Subject: McGuire Nuclear Station
Docket Numbers 50-369 and -370
Catawba Nuclear Station
Docket Numbers 50-413 and -414
Response to Conditions Relative to the
Use of Topical Report BAW-10173;
Supplement
(TAC Nos. 73771/73772)

Attachment I
Additional Response to Condition 1 for use of BAW-10173

Figure 1

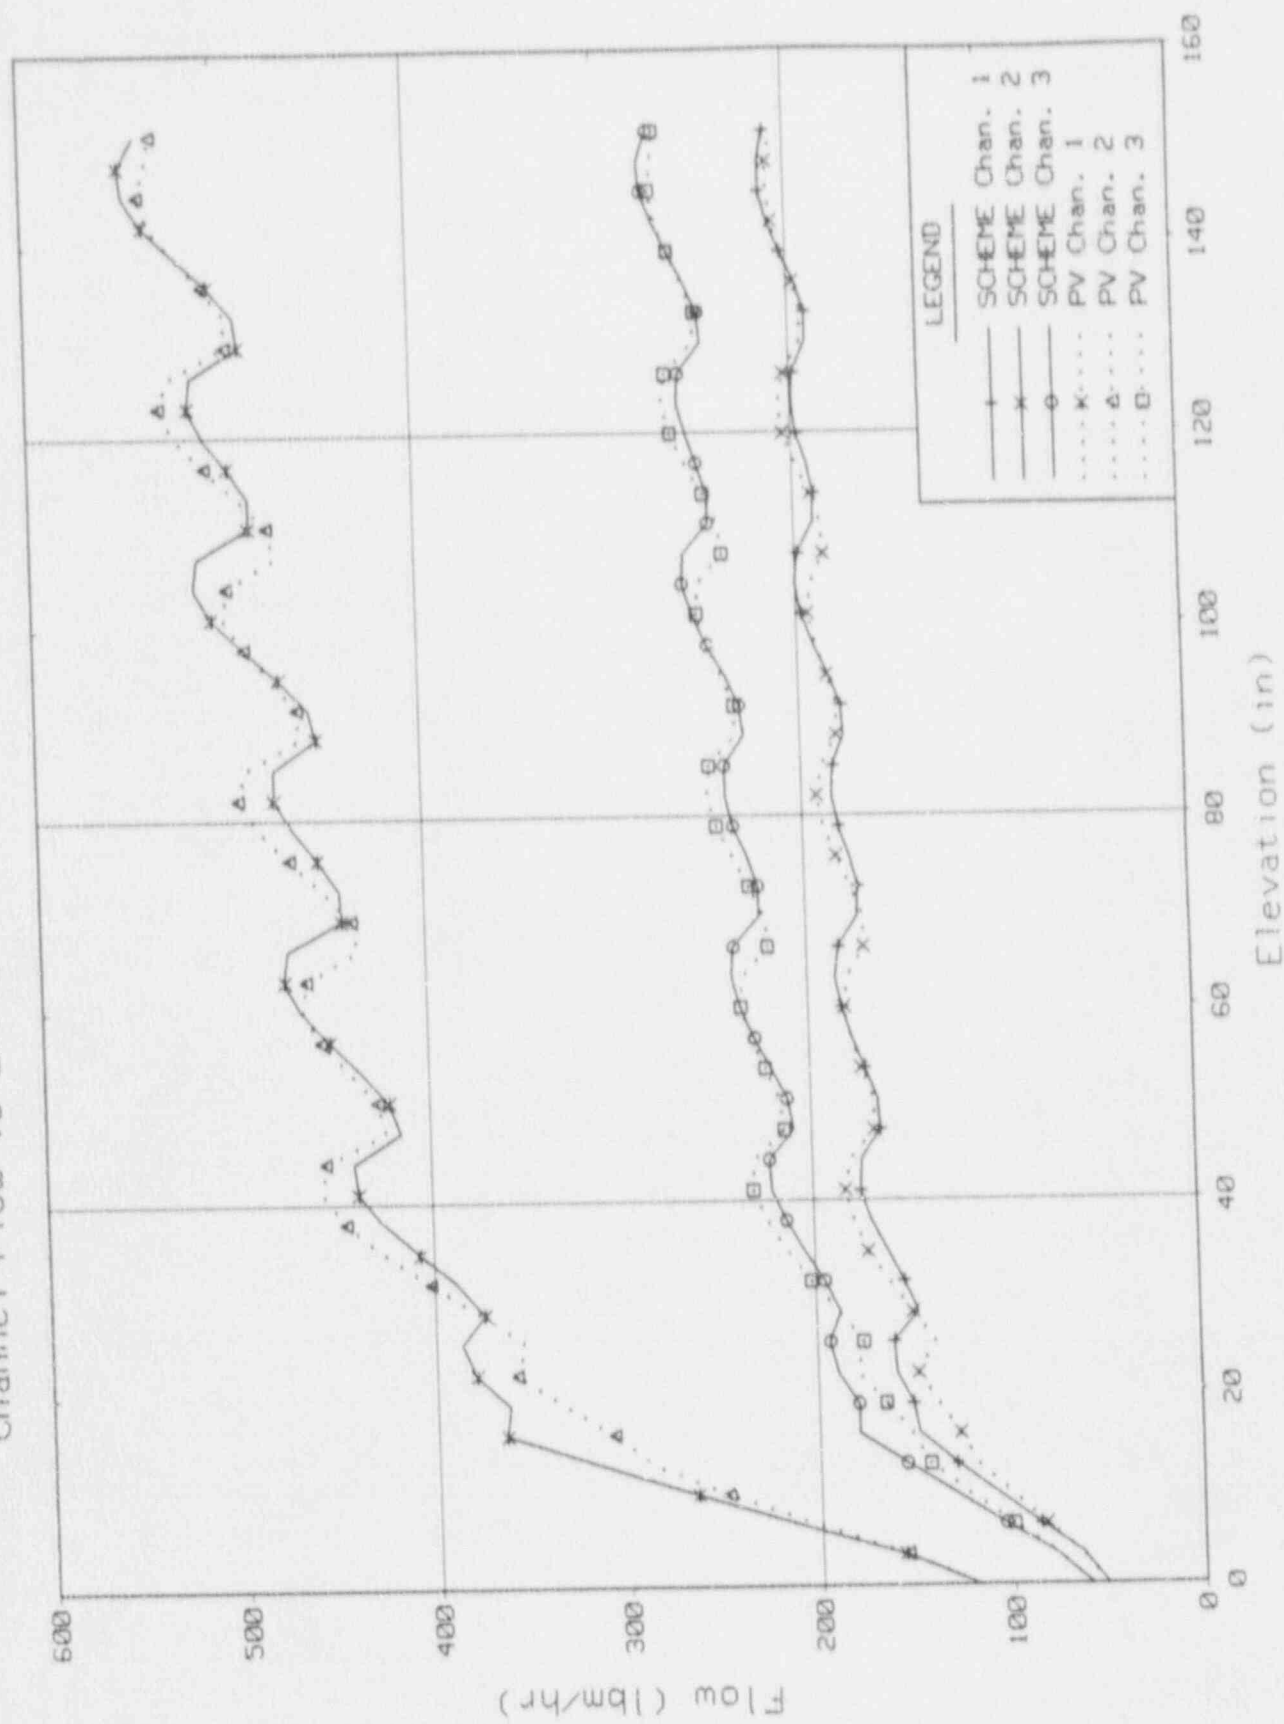
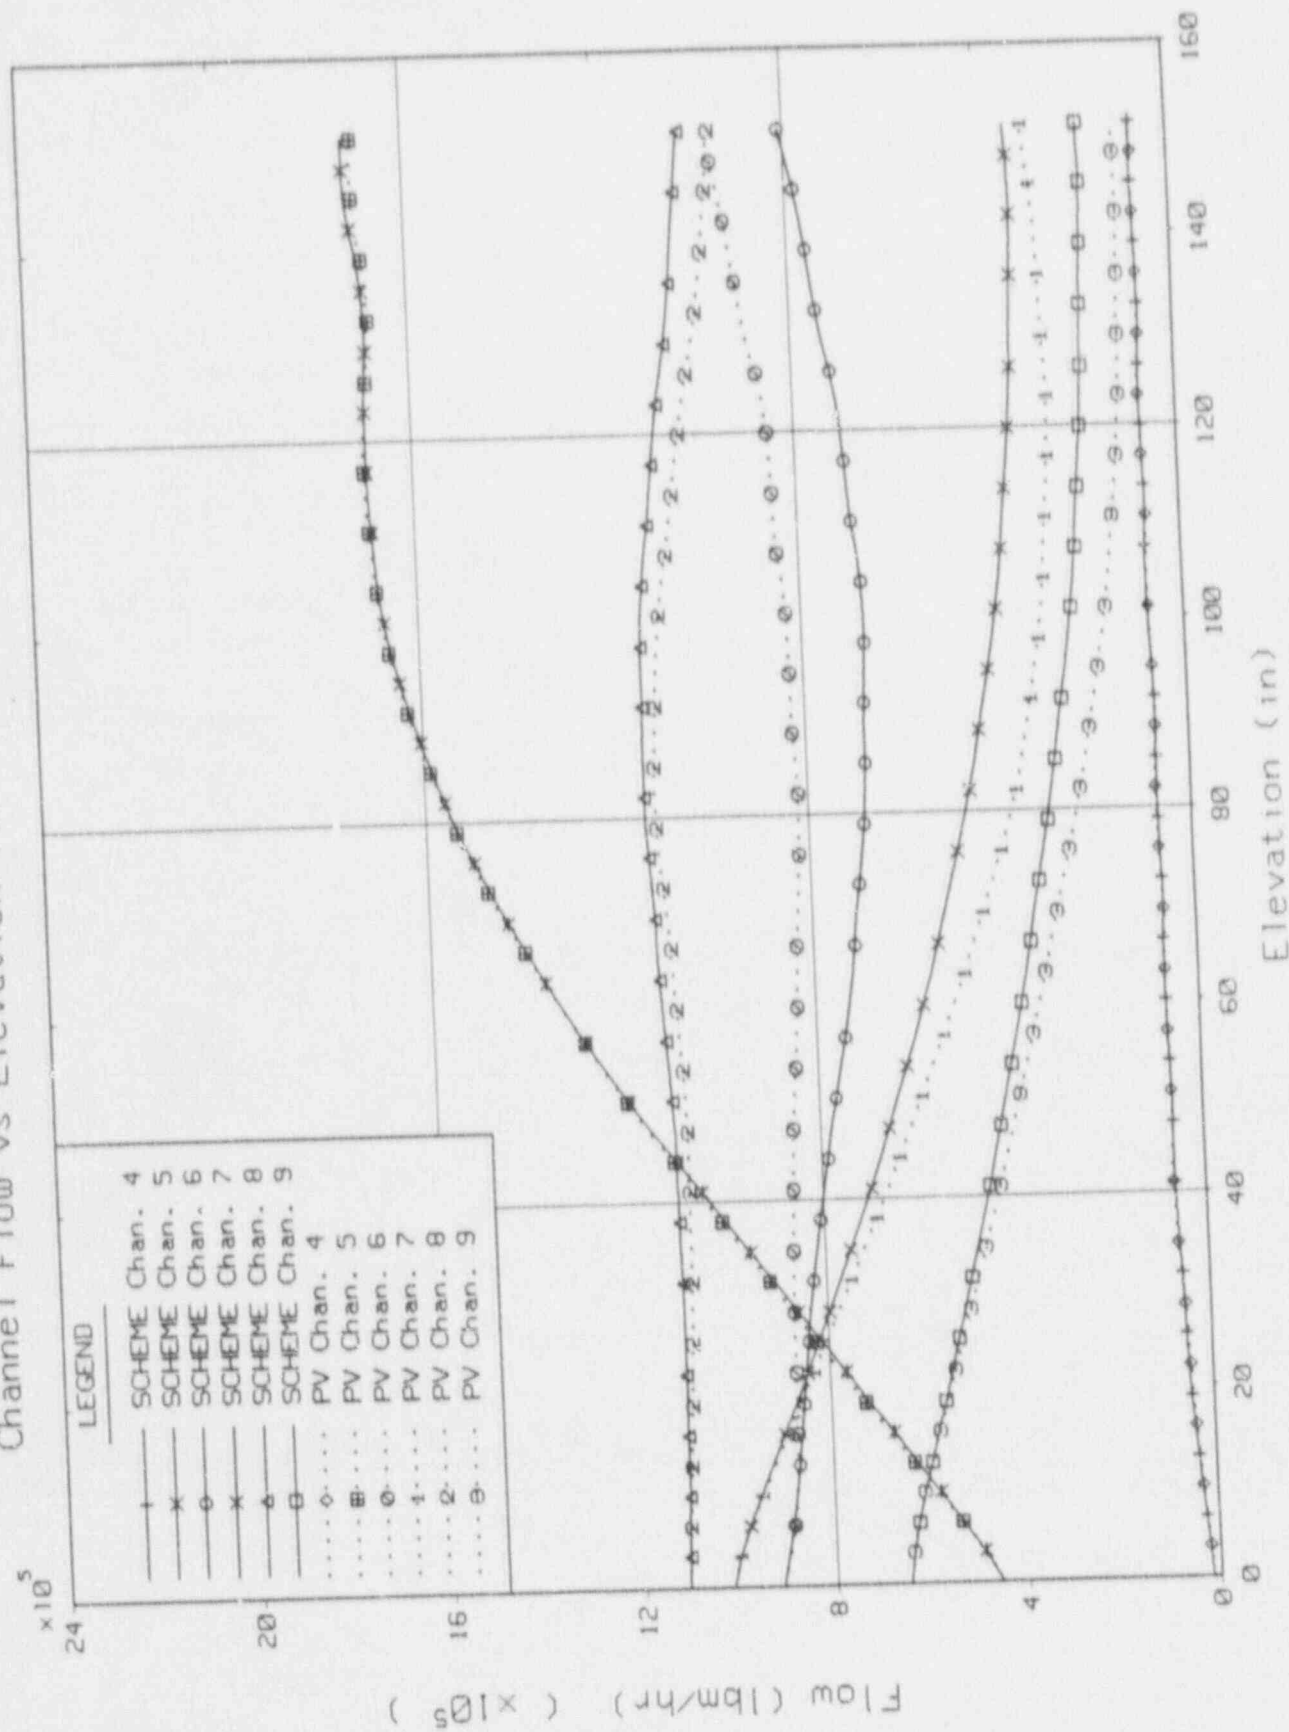
A benchmark analysis should be performed to verify appropriateness of the LYNXT modifications and modeling for the analysis of steam line break with loss of offsite power (SLB-LOOP). The benchmark analysis should be provided for staff review to confirm the acceptability of the SLB-LOOP analysis results.

thermal-hydraulic algorithm used for the solution. Figures 1 through 5 compare the results of the two cases. Figures 1 and 2 compare the flow rates of each channel. Figures 3 and 4 compare the channel enthalpies. Figure 5 shows that the minimum DNBR of the most limiting channel and rod differs by approximately 1 DNB point or 0.5% between the two cases. Analysis with the PV algorithm resulted in a minimum DNBR of 1.88 versus a value of 1.89 found using the SCHEME algorithm. The benefit of using the PV algorithm for this analysis is in the speed of problem execution and its ability to handle the arbitrary flow direction which can occur in some low flow problems. However, for this particular case both algorithms produced virtually equivalent results.
